CLAY FARM - DESIGN CODE

Testing Day Summary (23rd February 2010)

On Tuesday 23rd February 2010 Countryside Properties hosted a Design Code testing day at the request of Cambridge City Council. The purpose of the event was to ensure that the Clay Farm Design Code would deliver good quality design.

Parcel Data Sheet

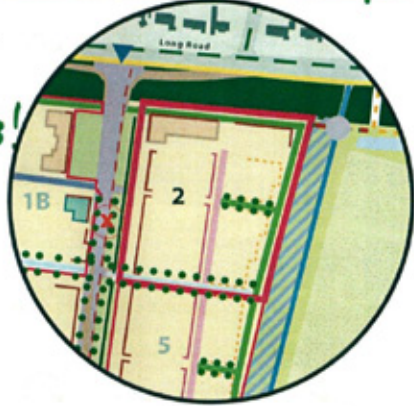
Add landscape hyperlines: Green Lane + N. Arrival Square

Parcel Number:	2
Area:	1.71 ha (4.23 acres)
Density Range:	40 - 60 dph 55
Unit Numbers:	68 - 104 (Target 70) 95
Storey Height Bands:	3-5 colour not consistent with parcel 1B
Key Buildings:	1

No warning re: spine road.

Parcel 1B - Possible Housing Layout

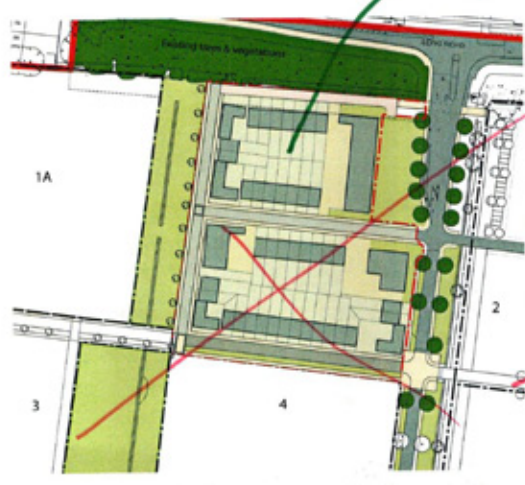
not necessary within the Data sheet as third party may consider layout is the ONLY way forward.

Parcel 2 - Possible Housing Layout

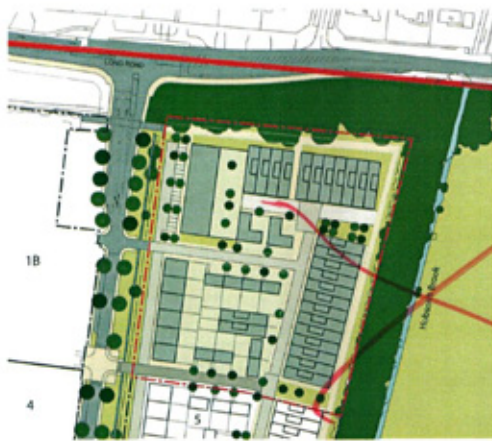
NOT needed

Parcel Data Sheet

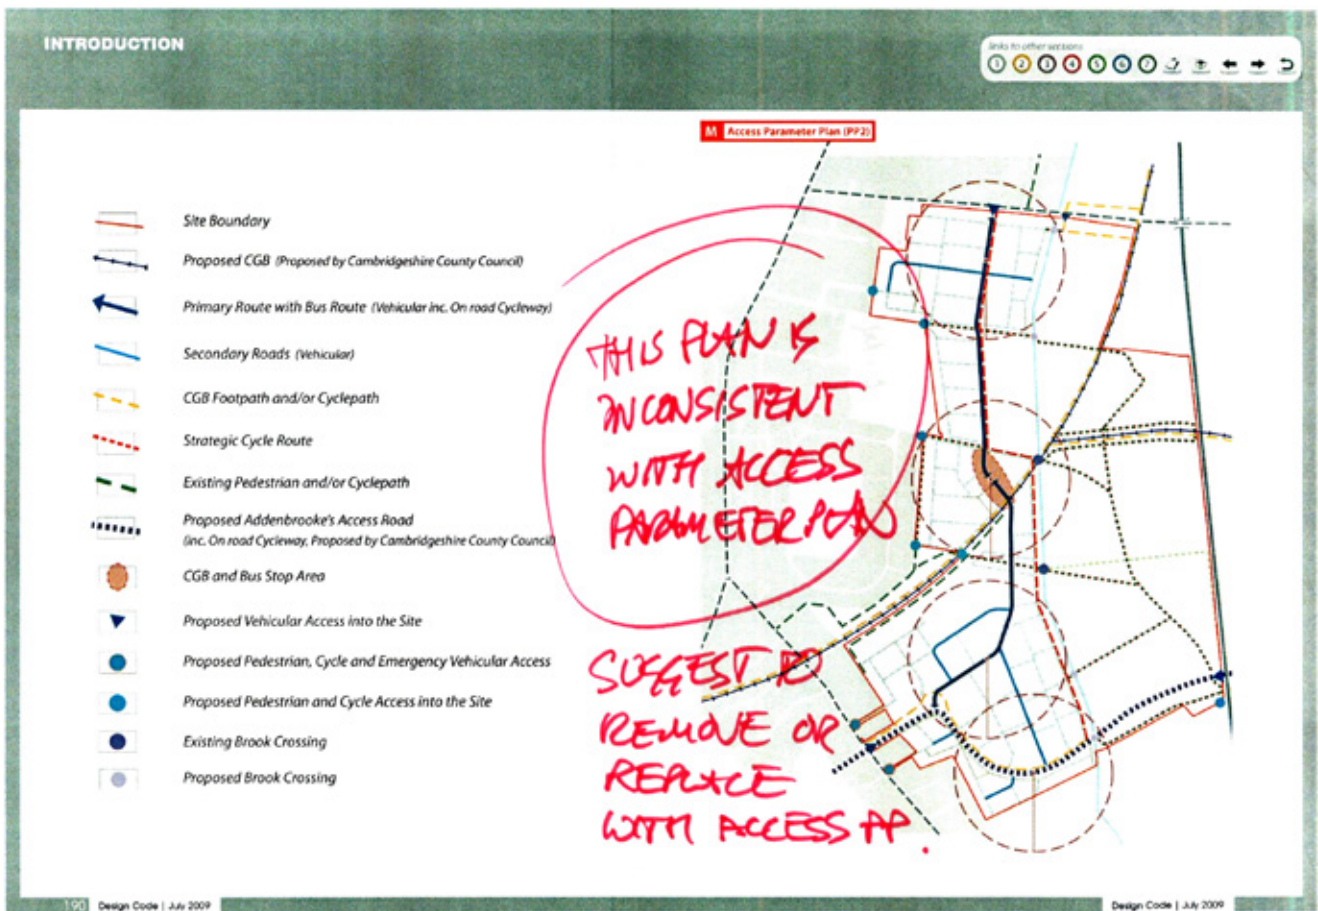
landscape hyperlinks MISSING

Parcel Number:	18
Area:	1.36 ha (3.36 acres)
Density Range:	40 - 60 dph 57
Unit Numbers:	54 - 83 (Target 83) 78
Storey Height Bands:	2-4 3-5
Key Buildings:	3 1-4

Too generic, not detailed enough to influence layout.

Quantum missing.

Road Types: (Within Parcel)	SECONDARY
	TERTIARY
	<i>green lane to add</i>
Drainage:	Surface Water Storage and Attenuation
	Surface Water Invert Level: 00.000 (at Spine Rd junction)
	Existing Ground Levels: min 00.000 - max 00.000
	Spine Road

WARNING - CHECK SPINE ROAD APPLICATION DRAWINGS FOR P.D.S ALIGNMENT

hyperlinks to technical drawing

SOUTHERN PARCEL

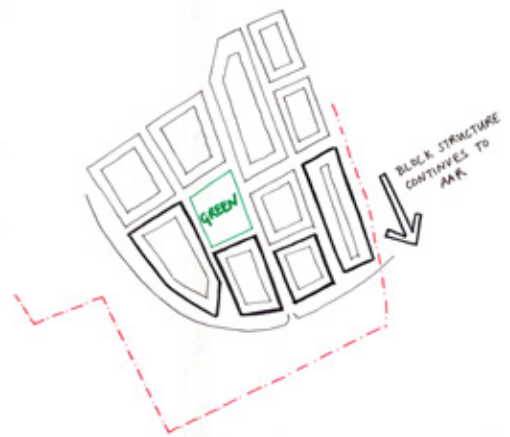
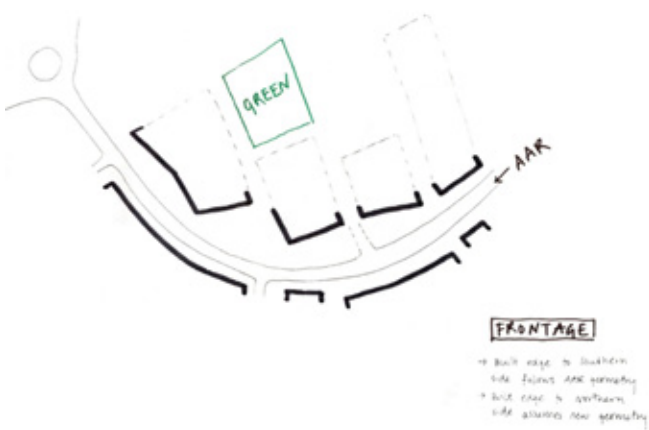
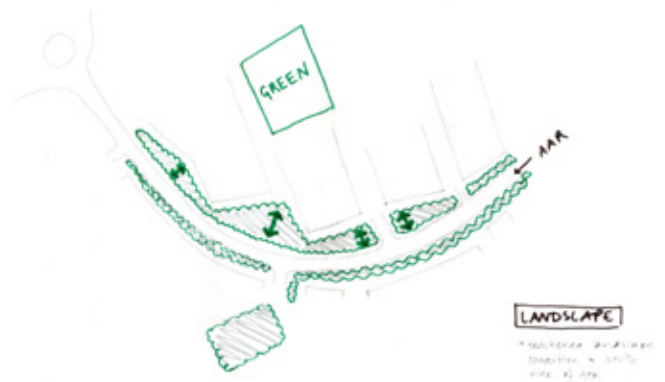
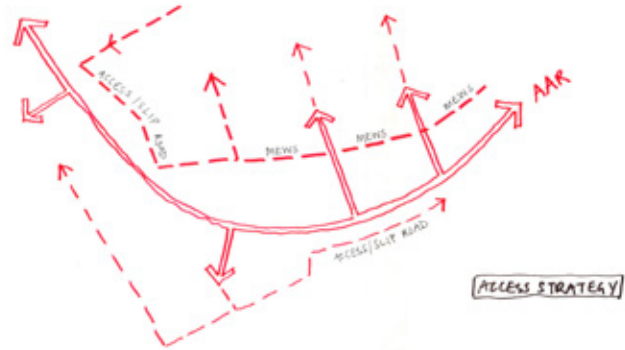
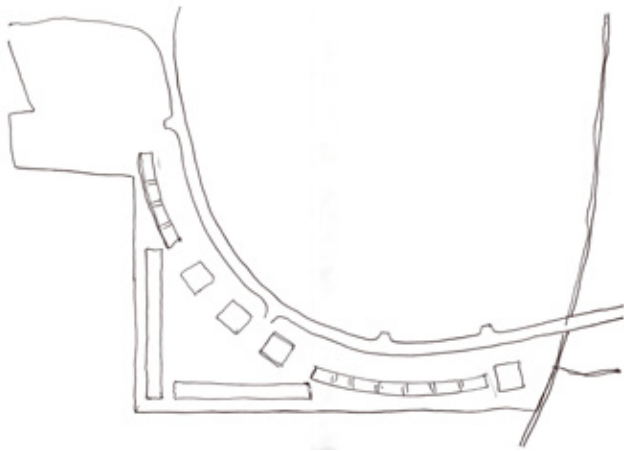
CROSS-SECTION OF EXISTING A.A.R.?

PEDESTRIAN CROSSING ON A.A.R. *

CODING CHARACTER ON WESTERN SIDE OF HOBSON'S BLOCK

REMOVE INTERFERING CYCLEWAY & INTEGRATE WITH INTERSECTIONAL NETWORK

* NUMBER AND TYPE (load surfacing, signs etc)
CONTROL OF POLLUTION FROM A.A.R STREET LIGHTS

PRIMARY SCHOOL SITE - ARRANGMENT 1

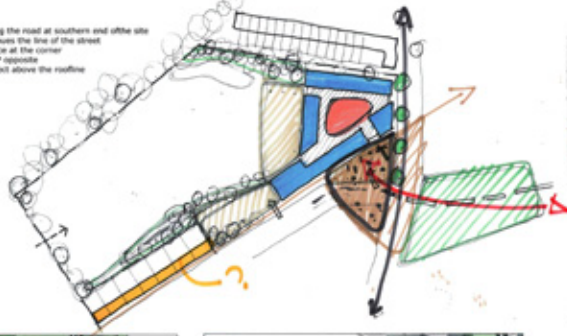
*Possible community use.
Space at entrance most*

PRIMARY SCHOOL SITE - ARRANGMENT 2

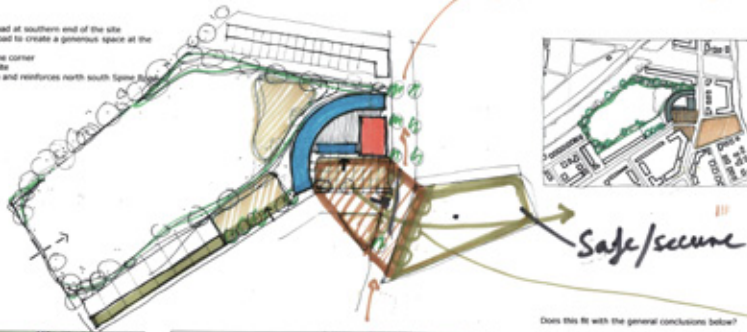
How do Countryside develop housing first... whilst allowing flexibility for school?

PRIMARY SCHOOL SITE - ARRANGMENT 4

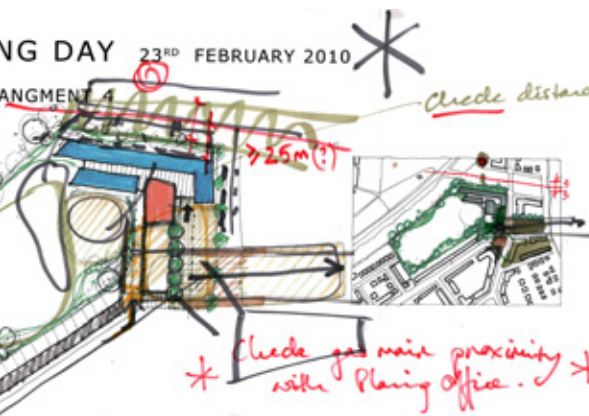
Bus stop positions?

* Check gas main proximity with Planning office. *

SECONDARY SCHOOL SITE - ARRANGEMENT 1 (NORTH END 1)

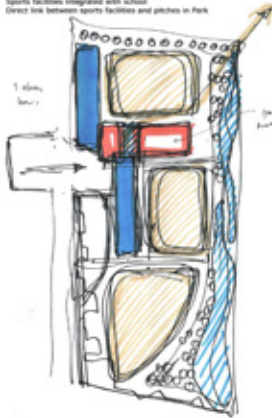
- Service access - cloak?
- Cycle paths
- Buffer to play area
- External access outside pitch

All weather pitch?
Sports Hall - canopy access?

SECONDARY SCHOOL SITE - ARRANGEMENT 2 (SOUTH END 1)

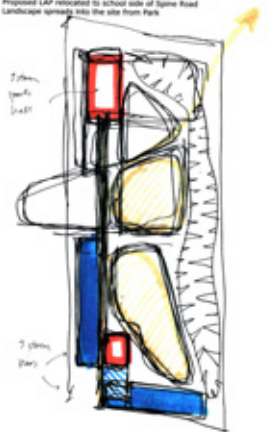
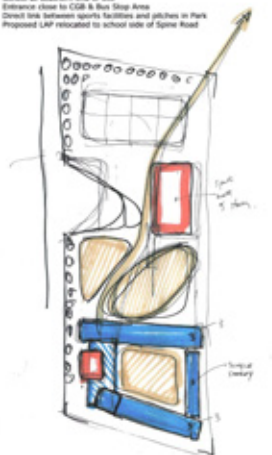
Noise... lights from pitch!

Relationship - Sports Hall, All Weather P, Pitch pitches.

LAP as part of canopy structure for Sports Hall etc.?

SECONDARY SCHOOL SITE - ARRANGEMENT 5 (PARK 1)

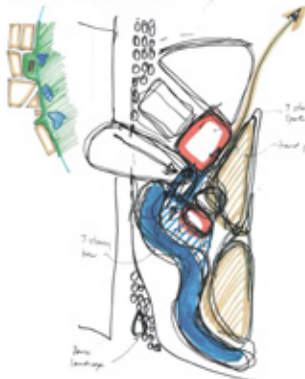
Floodlit pitches? Residents.

Civic importance... difference.

*Code the principles...
Not the design.*

Flexible parking, not 2 areas.

SECONDARY SCHOOL SITE - ARRANGEMENT 6 (PARK 2)

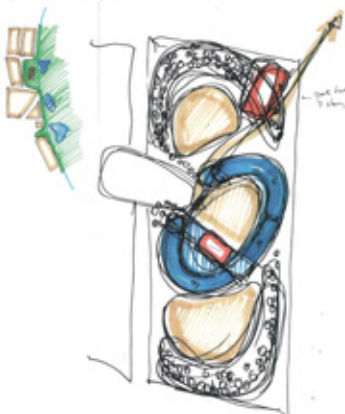
*Street scene & car parking.
Parking as part of Landscape Strategy - flexible space.*

'Councils parking standards for schools'

*Edge not defined as a solution.
Don't define railings!*

*Define environmental targets
not means of achieving them.
(siting etc.)*
